Area 22 & 23, St Leonards South
26-50 Park Rd, 27-47 Berry Road, 48-54 River Road

RESPONSE TO COUNCIL RFI

Area 20 River Road Frontage

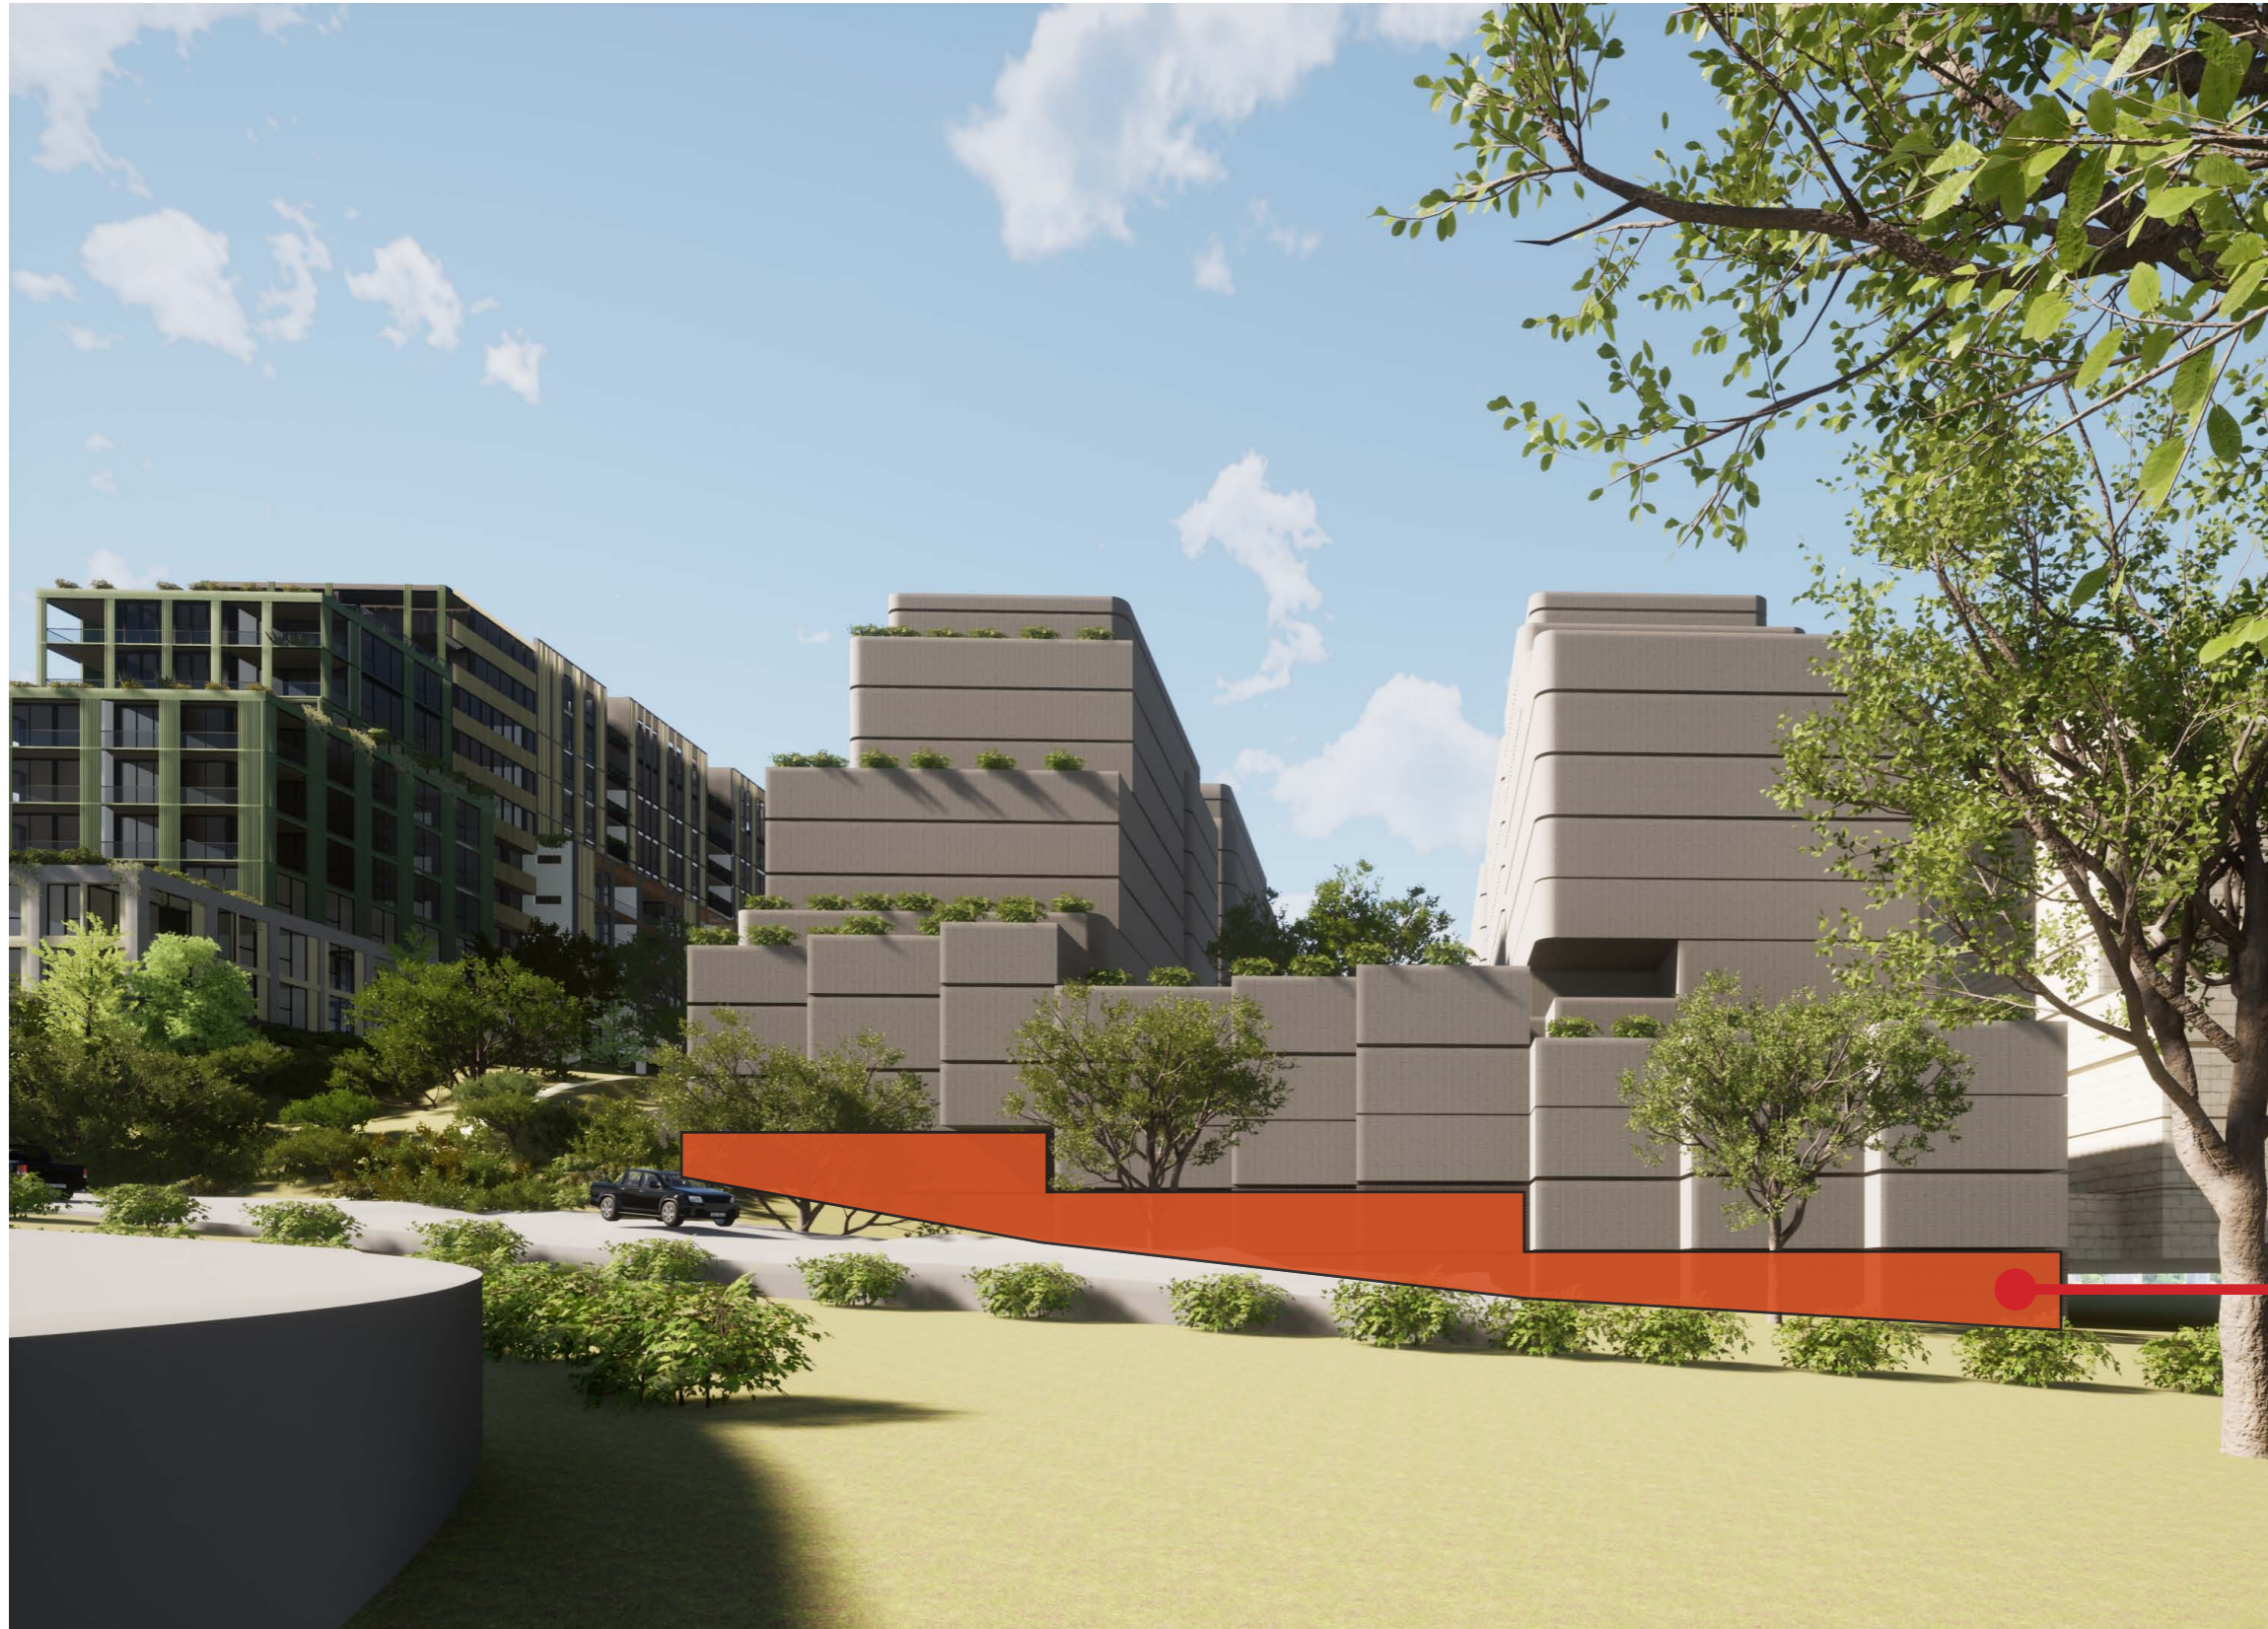
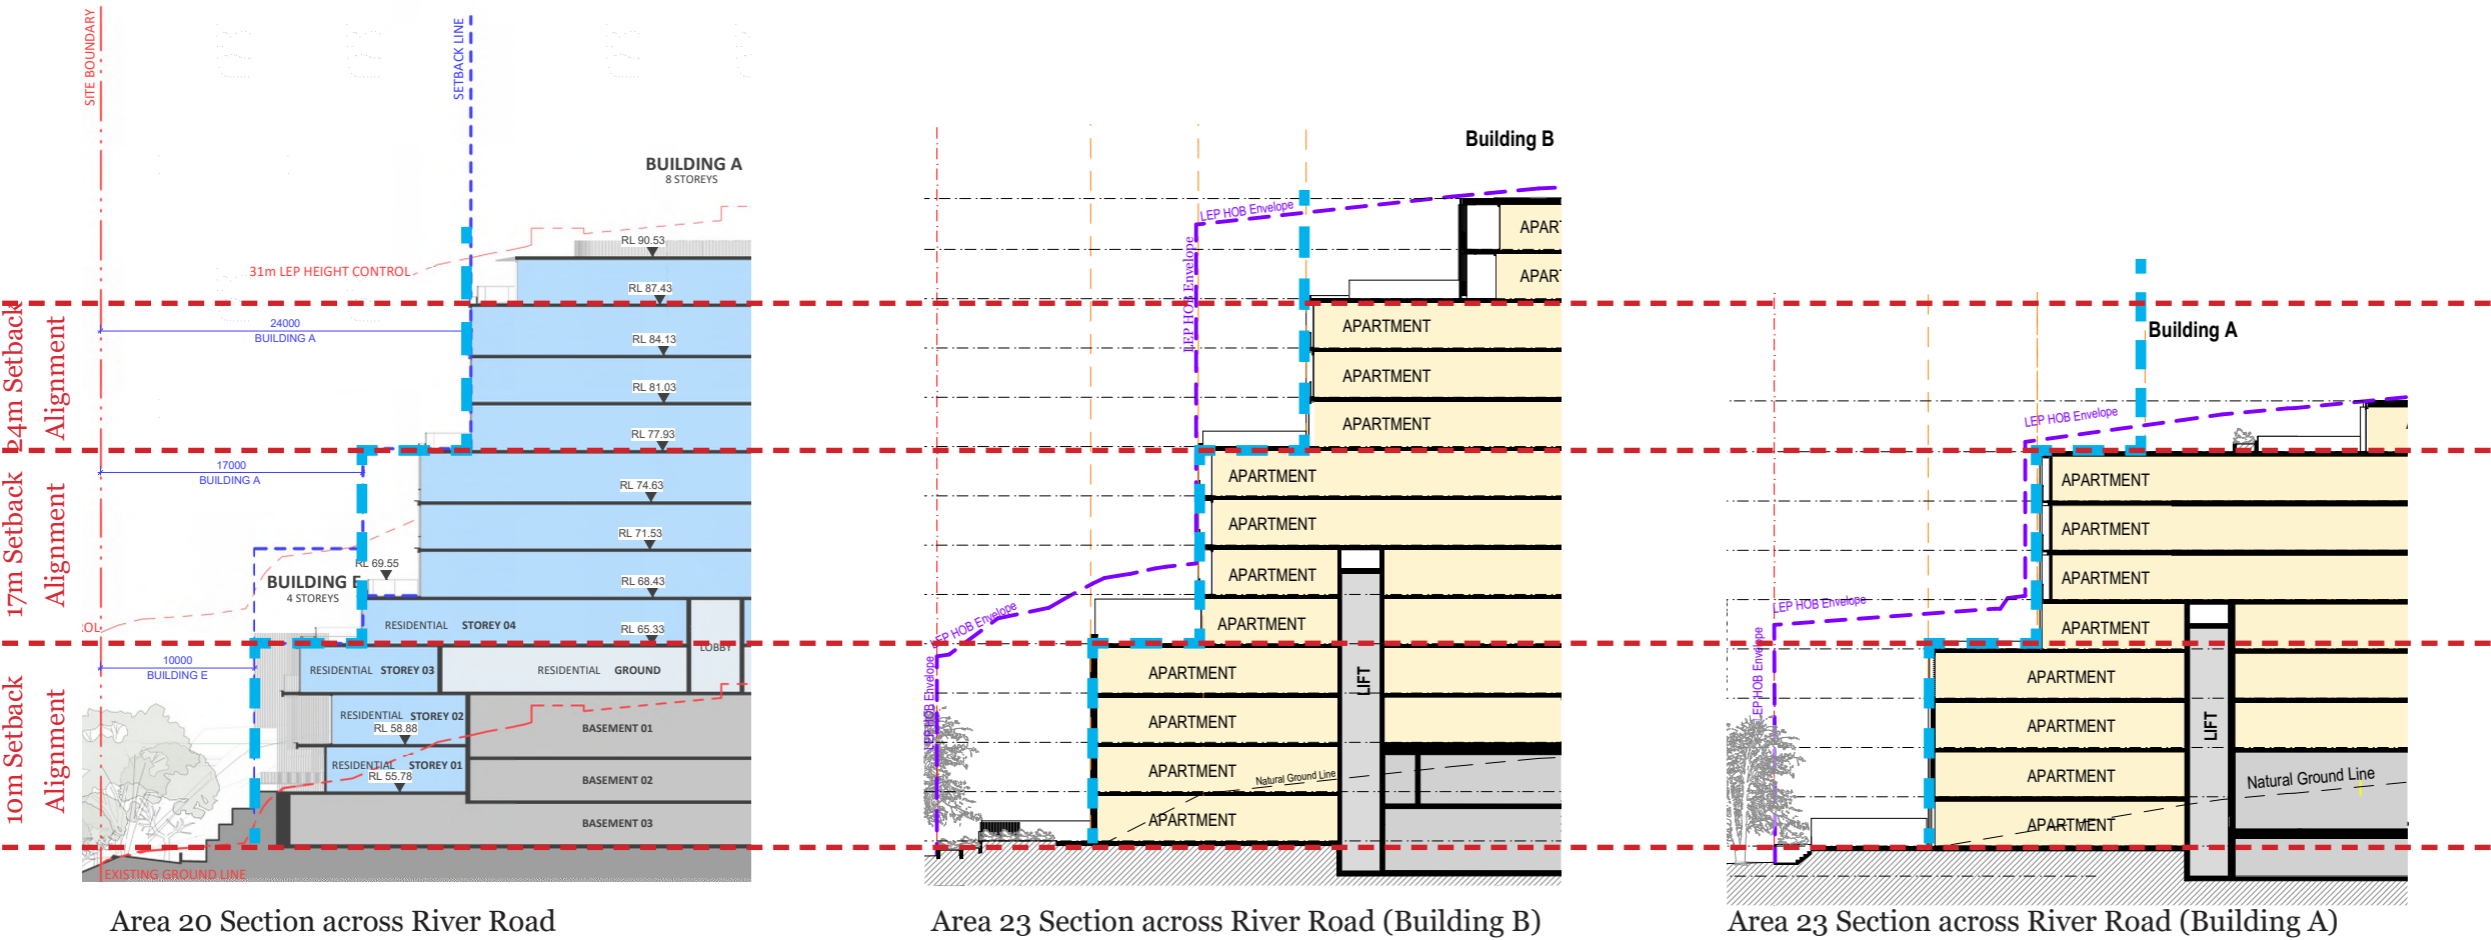
- Ground Floor raised 1-2 storeys above the street level along River Road.
- Blank walls highlighted in orange colour.

The proposed building massing achieves a consistent and complementary outcome to the approved form on Area 20.

The Council assessment report by Council stated the building fronting River Road was compliant in terms of the setback controls, which incorporated part storeys. This results in a physical increase of 1-2 storeys above the street level translating in an increased 'actual' street height built form.

By incorporating part storeys along this frontage, our proposal is consistent and thus the same methodology should be adopted by Council.

Our proposal archives a superior outcome however with active residential use at ground level as opposed to blank walls.

Council Comment
(Building C)

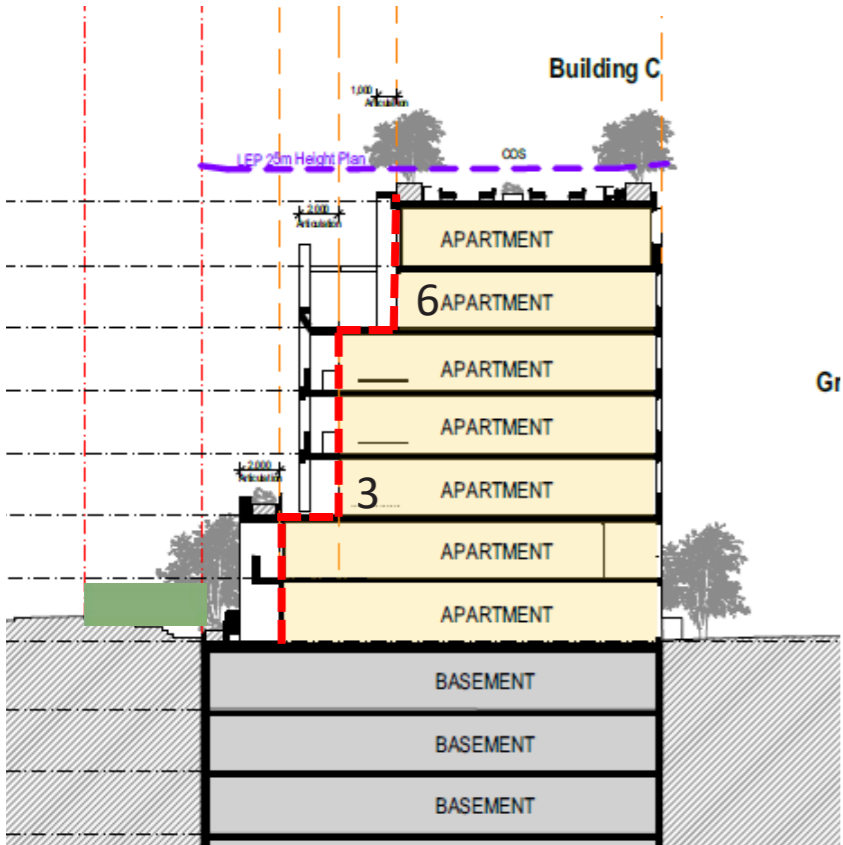
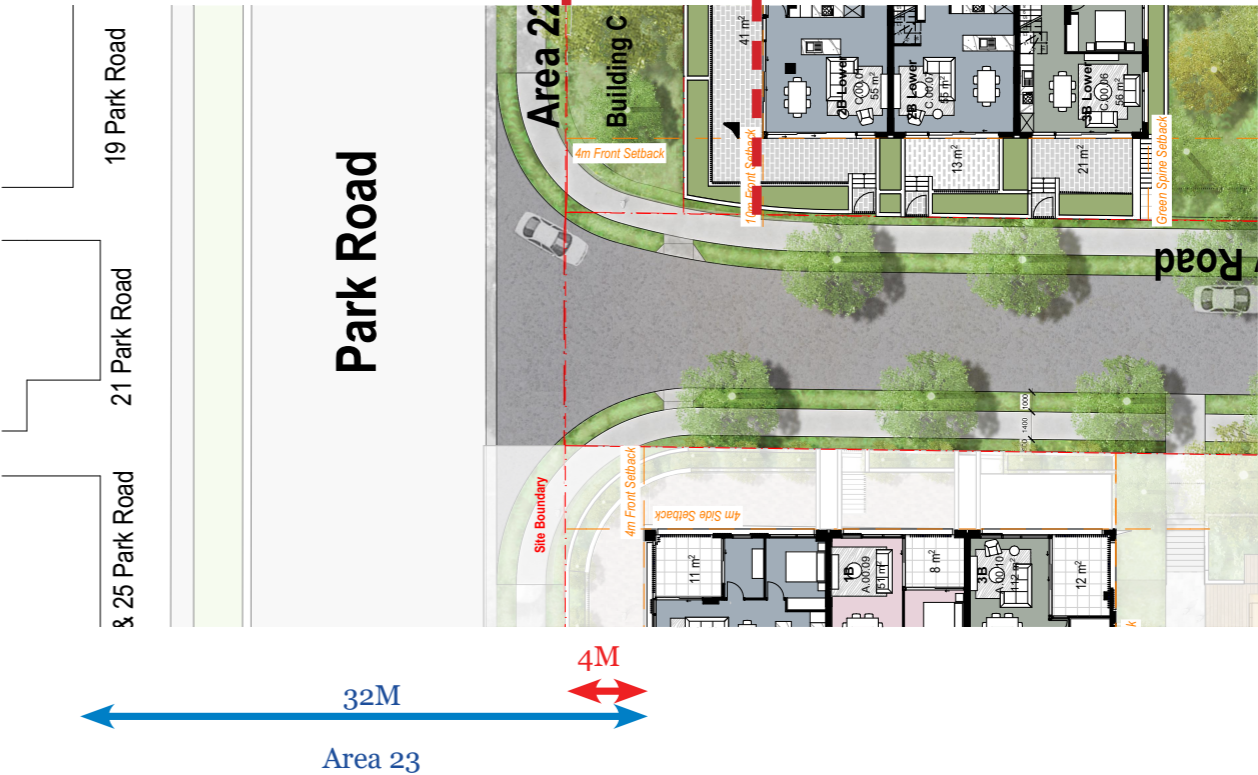
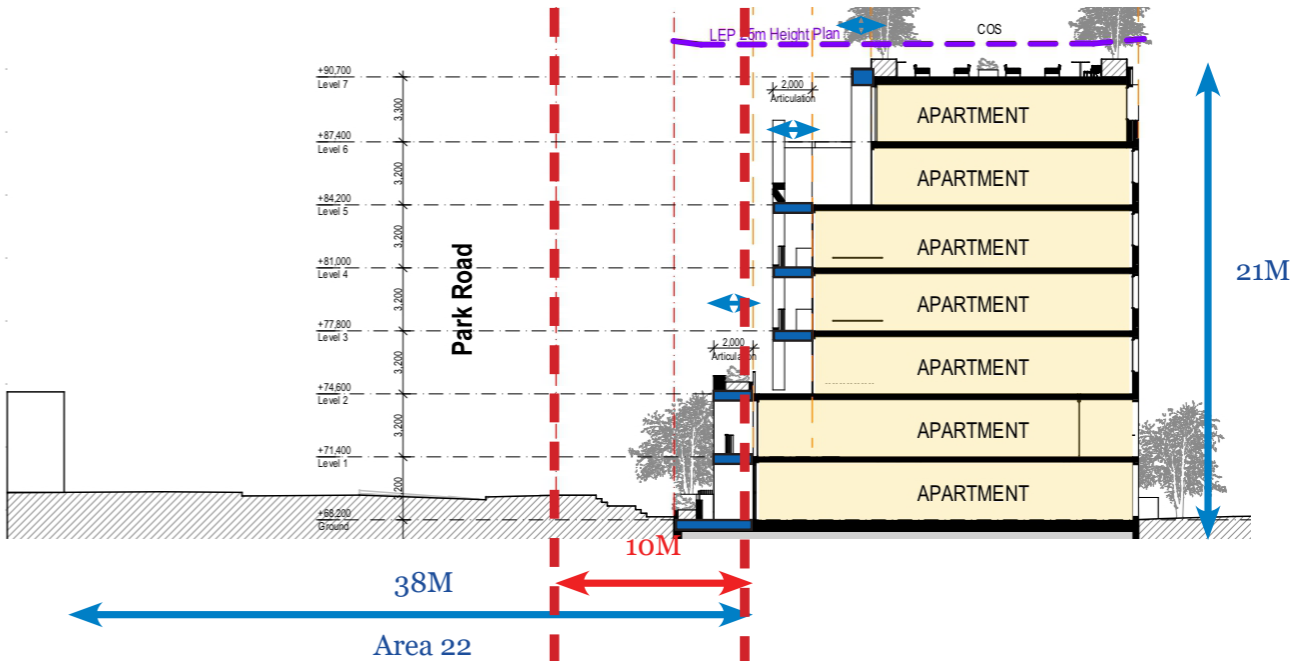
The proposed building setbacks do not comply with the DCP requirements at the following areas:

- Park Road frontage (Building C) 10m setback at level 1, 13m setback at level 3 and 16m setback at level 6 and above

The proportion of the street to build form

Council Comment

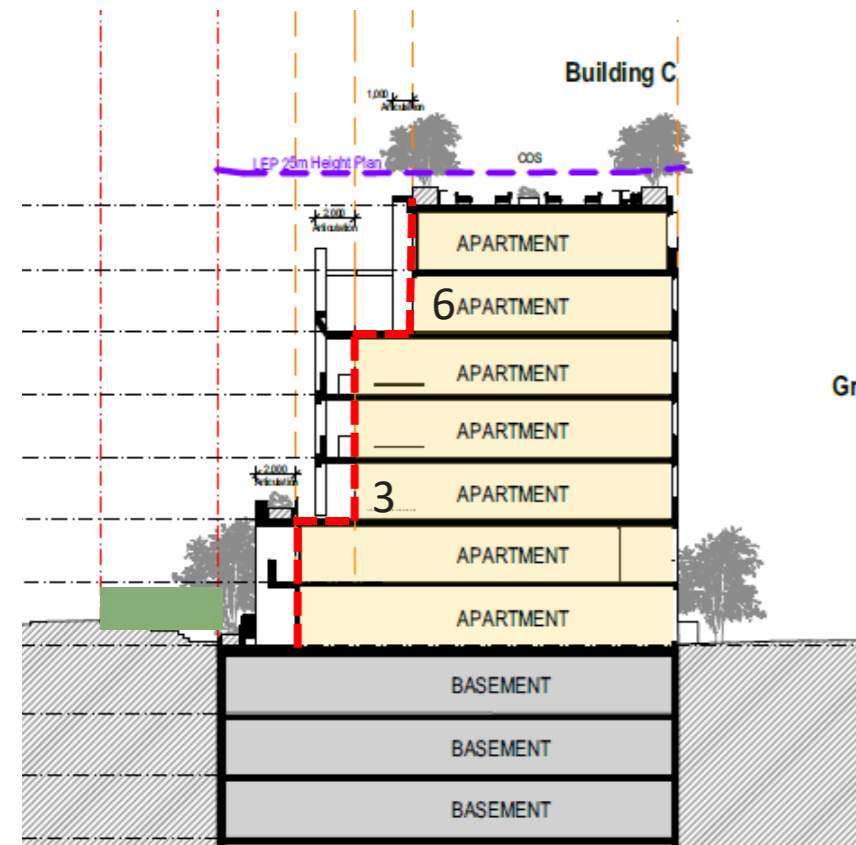
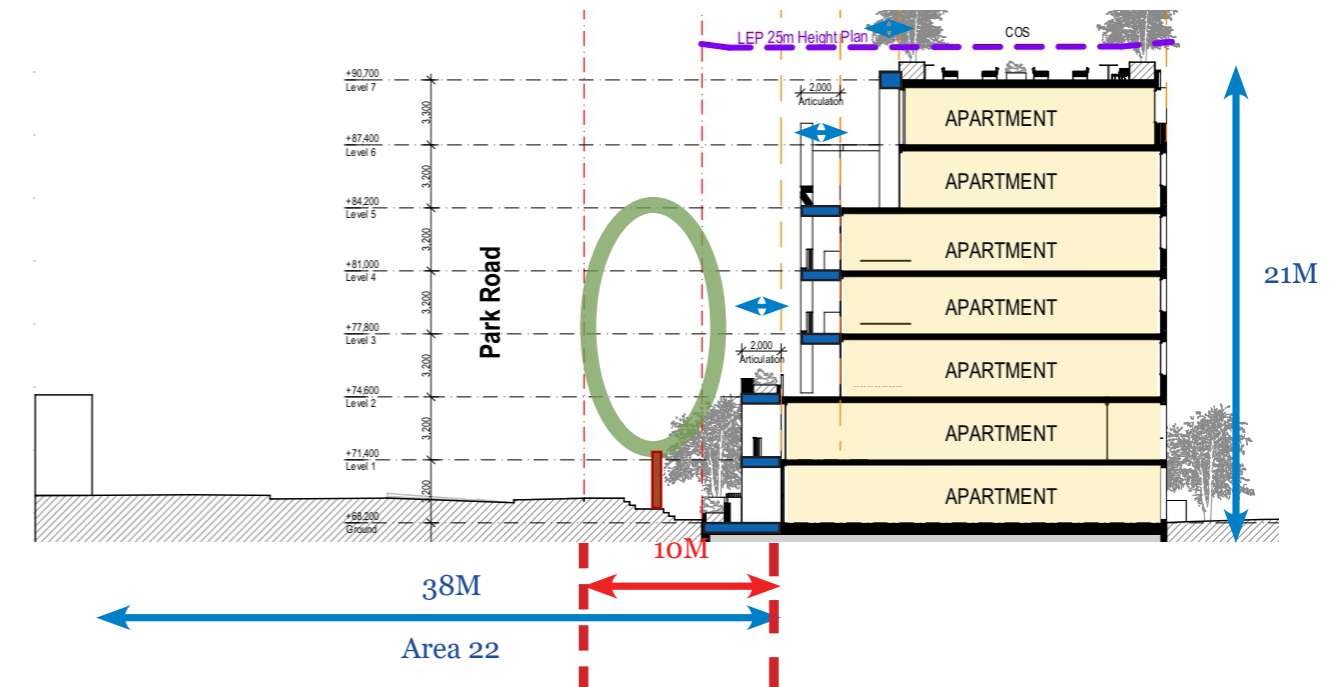
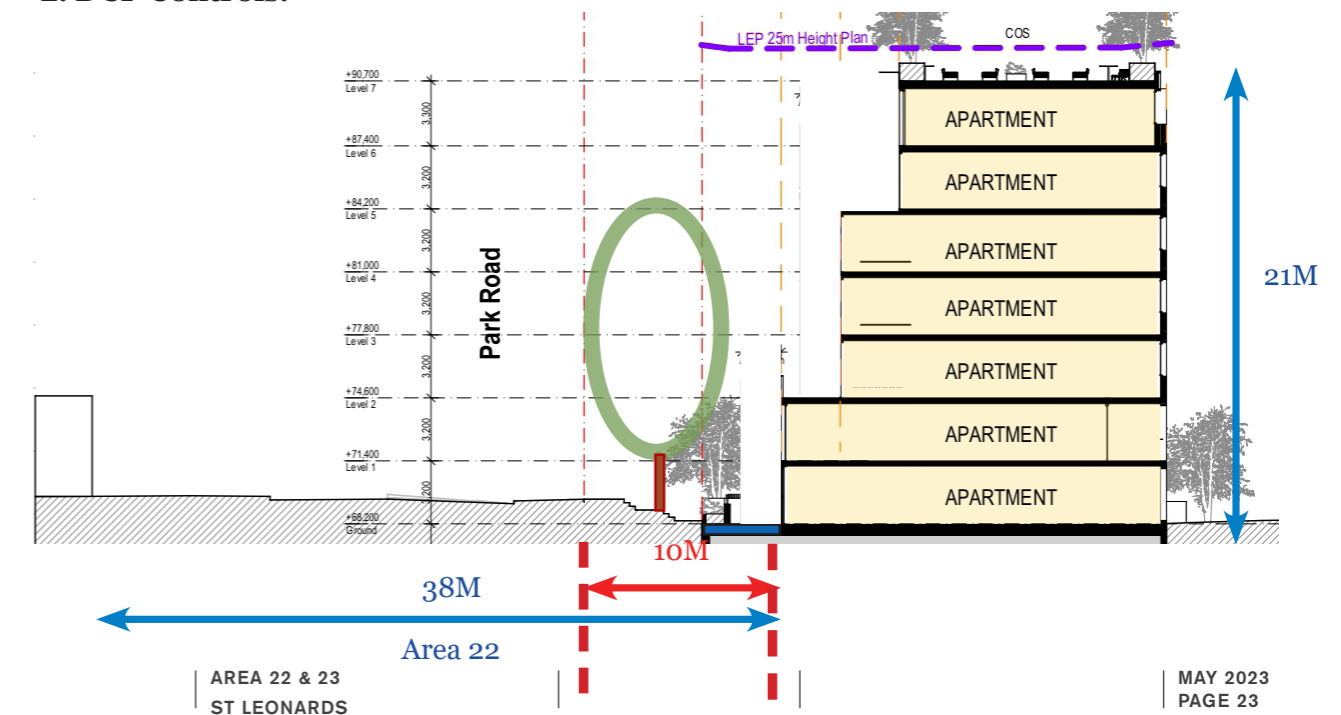
The proposed building setbacks do not comply with the DCP requirements at the following areas:

- Park Road frontage (Building C) 10m setback at level 1, 13m setback at level 3 and 16m setback at level 6 and above

Retention of existing trees. The bulk perceived from the other side of Park Road will not have much difference with the 2m breach.
